Mr. Casey, (RE: WDID 9 37C371859)

Casey Development-Parkview Estates Construction
1229 Saturn Blvd., San Diego 92154
WDID: 9 37C371859

Inspection Date: February 9, 2016
Inspector: Whitney Ghoram
San Diego Water Board

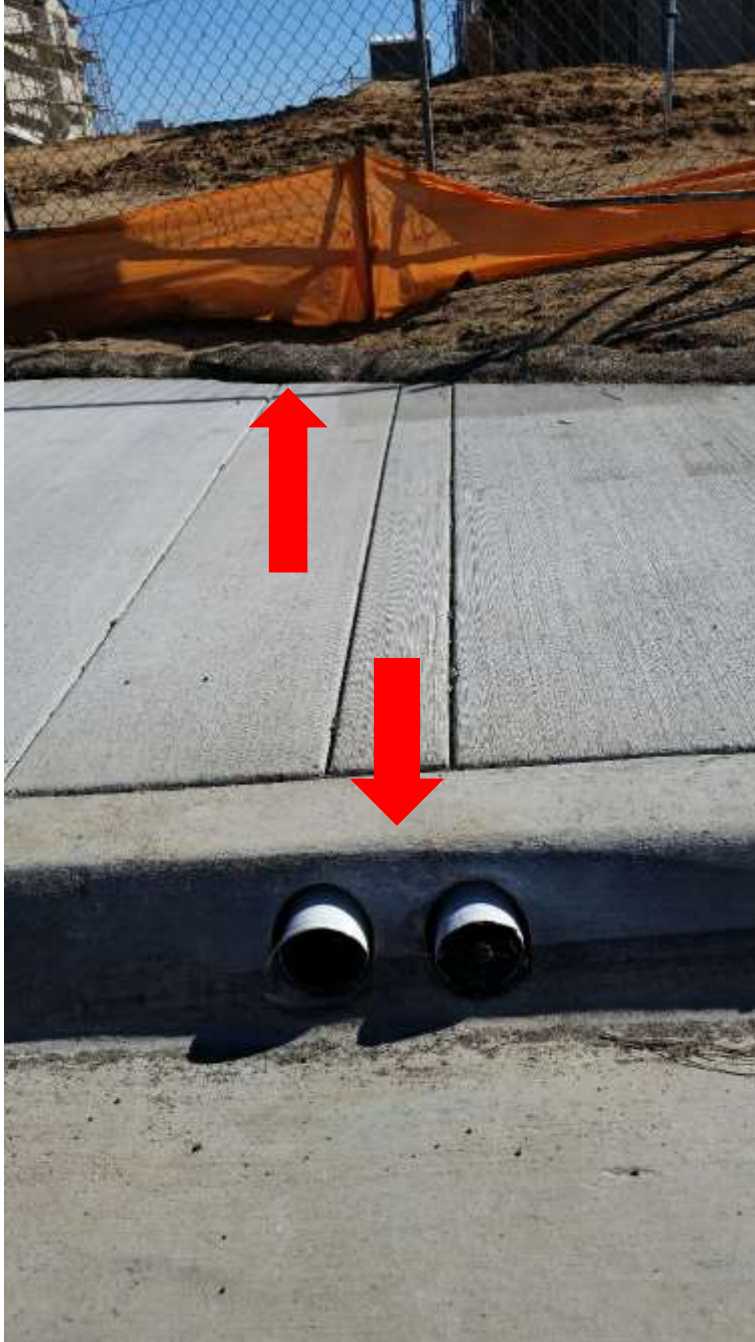
Worn and improperly installed fiber rolls. Exposed soil/sediment that should be stabilized per Risk Level 2 requirements.

Exposed soil/sediment.
